## 《混凝土結構作業守則 2013 年》

屋宇署已成立技術委員會，其工作包括向建築業界收集有關使用《混凝土結構作業守則 2013 年》（《混凝土守則 2013》）的意見及回應，並加以考慮。於 2017 年 6 月 13 日和 2020 年 11 月 24 日透過通告函件頒布的修訂，已納入現行的《混凝土守則 2013》（2020 年修訂版）。屋宇署因應技術委員會的建議，公布以下對《混凝土守則 2013》（2020 年修訂版）的修訂，並已上載於屋宇署網站（[www.bd.gov.hk](http://www.bd.gov.hk)）：

**Amendments to the Code of Practice for Structural Use of Concrete 2013 (2020 Edition)**  
**( February 2022 )**

**Amendments to the Code of Practice for Structural Use of Concrete 2013 (2020 Edition)**  
**( April 2024 )**

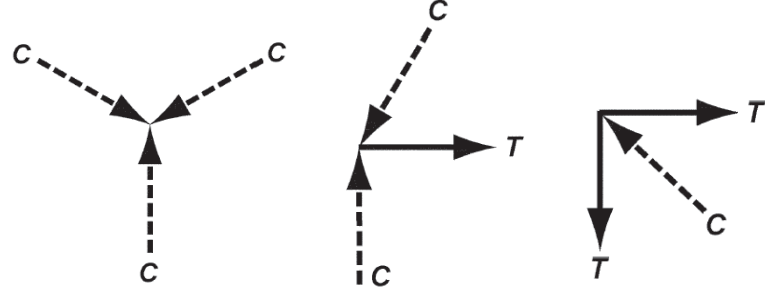
6. Clause 3.2.8.3 <sup>1</sup>	<p>3.2.8.3 Performance of type 1 mechanical couplers</p> <p>Type 1 mechanical coupler satisfying the following criteria may be used as an alternative to tension or compression laps:</p> <p>(a) when a representative gauge length assembly comprising reinforcement of the diameter, grade and profile to be used, and a coupler of the precise type to be used, is tested in tension the permanent elongation after loading to <math>0.6f_y</math> should not exceed <math>0.1 \text{ mm}^1</math>; and .....</p>	<p>3.2.8.3 Performance of type 1 mechanical couplers</p> <p>Type 1 mechanical coupler satisfying the following criteria may be used as an alternative to tension or compression laps:</p> <p>(a) when a representative gauge length assembly comprising reinforcement of the diameter, grade and profile to be used, and a coupler of the precise type to be used, is tested in tension the permanent elongation after loading to <math>0.6f_y</math> should not exceed <math>0.1 \text{ mm}^1</math>;</p> <p>(b) For couplers longer than 100 mm, the permanent elongation greater than <math>0.1 \text{ mm}</math> may be accepted as per Figure 3.9a subject to crack width control requirements in clauses 7.2.1, 9.4.1 and 12.3.4; and</p> <p>(c) the coupler bar.....</p>

<sup>1</sup> Addition of maximum allowable permanent elongation for mechanical couplers longer than 100 mm.

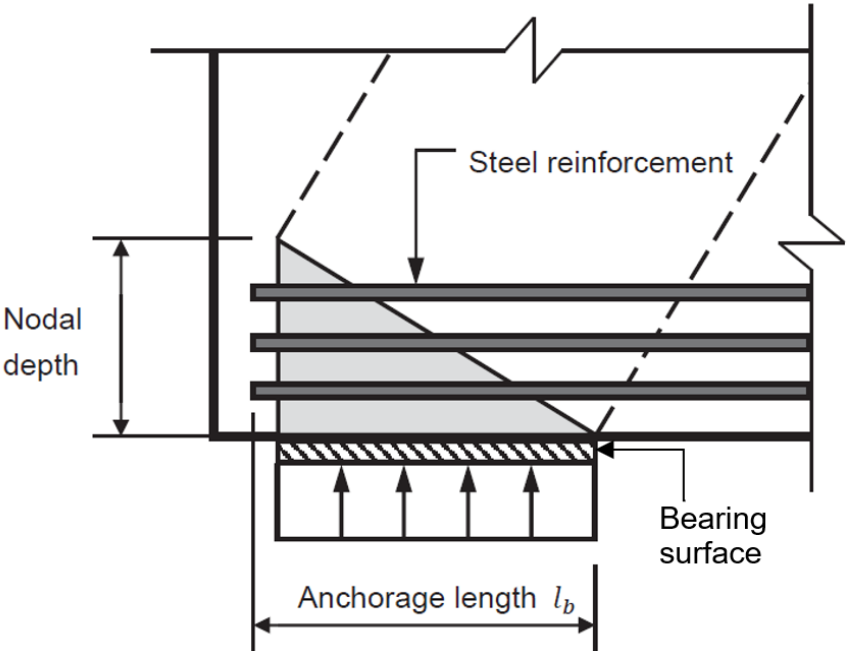
8. Clause 6.9 <sup>2</sup>		<b>6.9 STRUT-AND-TIE SYSTEM</b> <b>6.9.1 General</b> <b>Non-flexural components, e.g. locations near supports and concentrated loads, of reinforced concrete structures can be</b>

Item	Current version	Amendments
		<p>designed using strut-and-tie model. A strut-and-tie model is an idealized pin-jointed truss, comprising concrete compression struts, reinforcement tension ties, and concrete nodes.</p> <p><b>6.9.2 Modelling and analysis</b></p> <p>The angle between the axis of a strut and the axis of a tie (<math>\theta</math>) shall not be less than <math>25^\circ</math> nor exceed <math>60^\circ</math>. The boundary forces and the internal forces can be determined based on the static equilibrium and the truss analysis.</p> <p>The dimensions of nodes shall be determined based on the nodal condition shown in Figure 6.21 by using the static equilibrium corresponding to shear failure and plastic stress state (see Figure 6.22).</p>  <div style="border: 1px solid black; padding: 5px; width: fit-content; margin: 10px auto;"> <math display="block">F_s = \sqrt{F_1^2 + F_2^2}</math> <math display="block">l_s = l_1 \cos \theta + l_2 \sin \theta</math> <math display="block">\sigma_s = F_s / (l_s \times \text{breadth})</math> </div> <p><b>Figure 6.21 – Nodal condition</b></p>

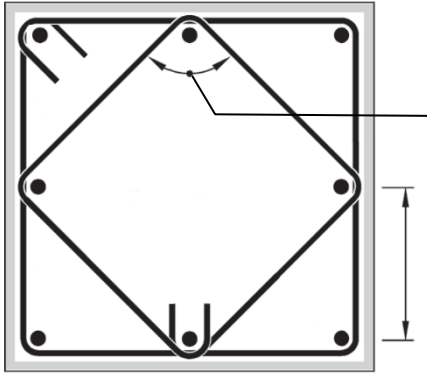
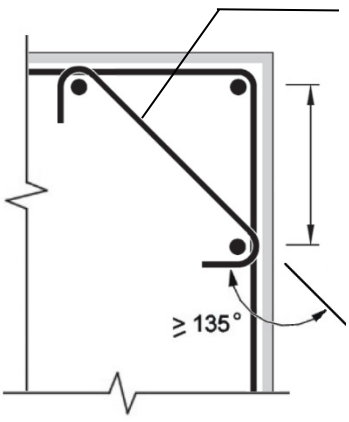
Item	Current version	Amendments
		 <p data-bbox="1303 561 2027 598">Figure 6.22 – Static equilibrium of a strut-and-tie model</p> <p data-bbox="1236 635 1429 671">6.9.3 Design</p> <p data-bbox="1236 676 1809 713">6.9.3.1 Design compressive strength of strut</p> <p data-bbox="1339 715 2094 783">Design compressive strength of concrete in strut <math>f_{cc}</math> should be calculated from:</p> $f_{cc} = 0.32mf_{cu} \quad 6.74$ <p data-bbox="1339 895 1420 932">where</p> <p data-bbox="1370 933 2094 970">m is the confinement modification factor taken as</p> $\sqrt{\frac{A_2}{A_1}} \leq 2,$ <p data-bbox="1370 1048 1637 1085"><math>A_1</math> is loaded area,</p> <p data-bbox="1370 1086 1989 1123"><math>A_2</math> is load distribution area (see Figure 6.23).</p>

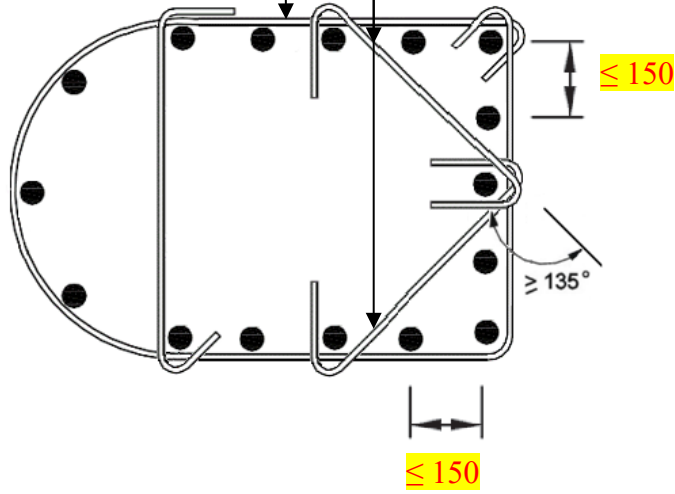
Item	Current version	Amendments
		<p data-bbox="1339 256 1653 292"><b>(b) Arrangement of ties</b></p> <p data-bbox="1395 295 2096 435">The reinforcing bars in a tie shall be evenly distributed across the nodal depth such that the centroid axis of the reinforcing bars coincides with the axis of the tie in the strut-and-tie model.</p> <p data-bbox="1339 480 1626 515"><b>(c) Anchorage of ties</b></p> <p data-bbox="1395 518 2096 770">The reinforcing bars in a tie shall be properly anchored to transfer the tension force into the node through adequate anchorage of longitudinal reinforcement in accordance with clause 8.4. The anchorage begins at the location where the edge of strut meets the bearing surface (see Figure 6.25). For straight bars, they shall be extended beyond the node.</p>
